Farm Road Yellow Lines and Bus Route 456

Appendix C – Discussion of Local Opposition to Proposals

Part 1: Farm Road Yellow Lines and Bus Stops

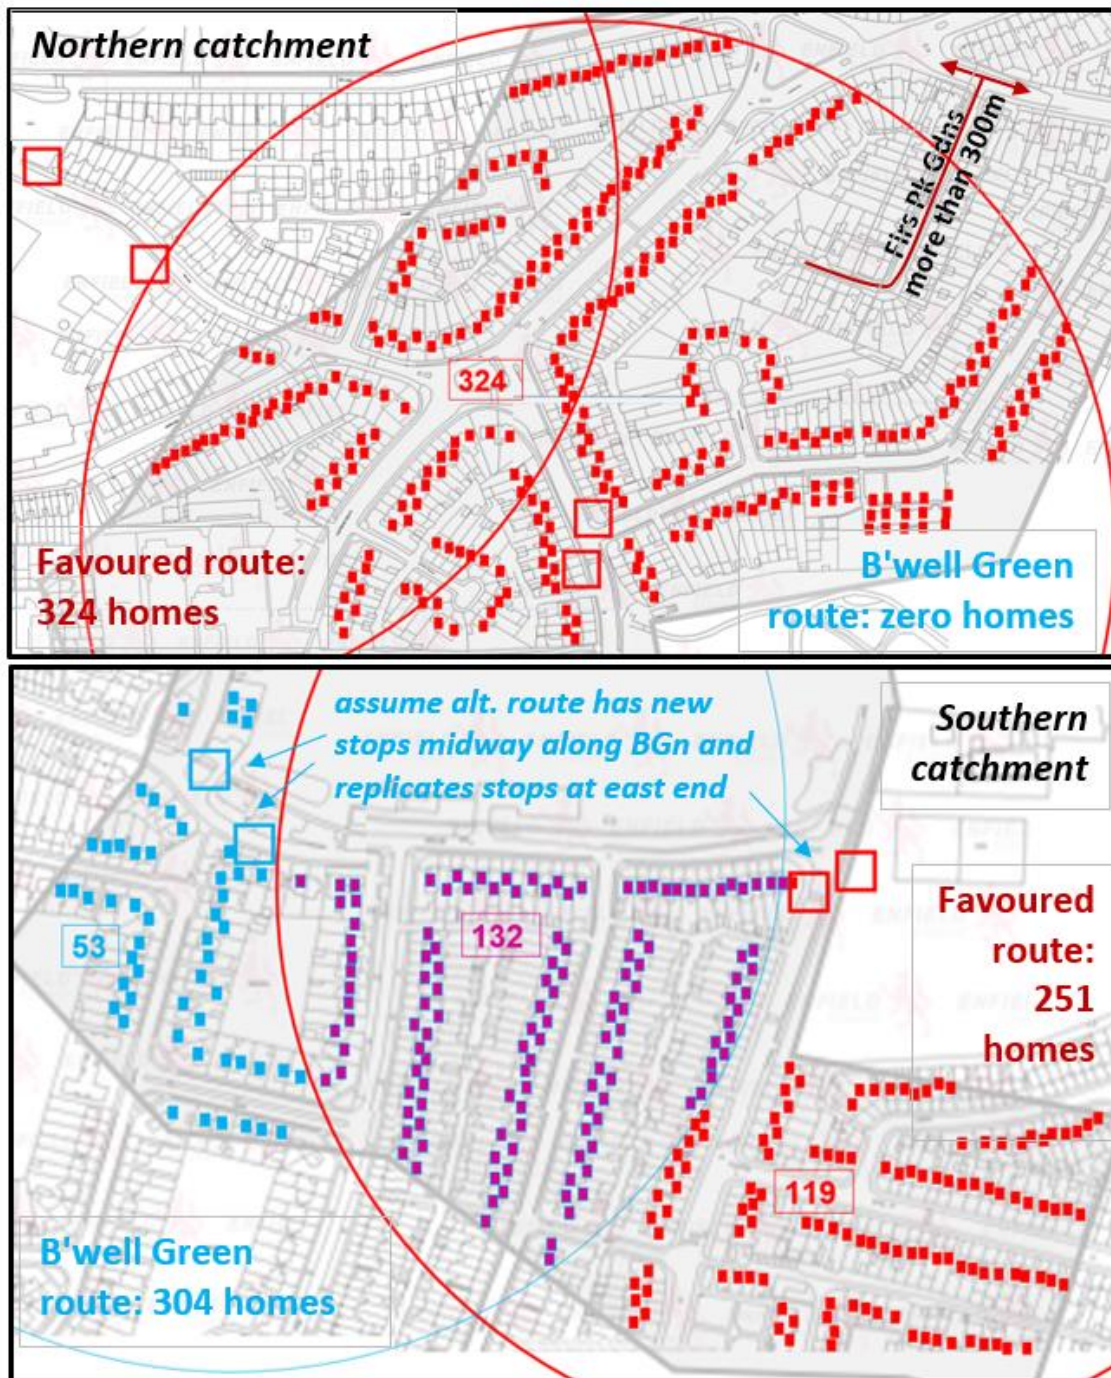
44. The analysis is based on drawing catchment circles of 300m radius around all the existing bus stops on the enclosing corridors - Green Lanes, Church Street and the A10 – as well as indicating similar coverage for Hedge Lane's hail and ride service. The area (shaded grey in the mapping below) bounded by the perimeter route catchment circles is the unserved area of housing sitting beyond short walking distance of existing bus services. The distance of 300m is chosen, rather than the maximum desired 400m bus stop spacing figure quoted above, to reflect that not all homes within a circle are on a direct walking route to the stop.

46. The home-by-home level analysis seen below shows that the Farm Road option captures 324 homes from the northern 'hole' and 251 from the south, totalling 575. The Barrowell Green option does not capture new homes to the north on Firs Lane etc, due to the large area of open space separating the route from the nearest areas of housing. Its addition of 304 homes to the south better the Farm Road option by only 53 homes. Hence we can conclude that the Barrowell Green option brings 304 homes within short walking distance of a bus stop, but that this is only 53% of the 575 gains made by the favoured option.

47. Accordingly TfL's judgement appears sound in having chosen the option that is most direct, serves most homes and avoids duplicating services along Green Lanes. By those factors it is maximising the potential of the route to convert trips from car to bus; offering passengers along all parts of the route the optimum in accessibility, convenience and journey times; and minimising any bus-on-bus delays or confusion by duplicating other bus services on Green Lanes.
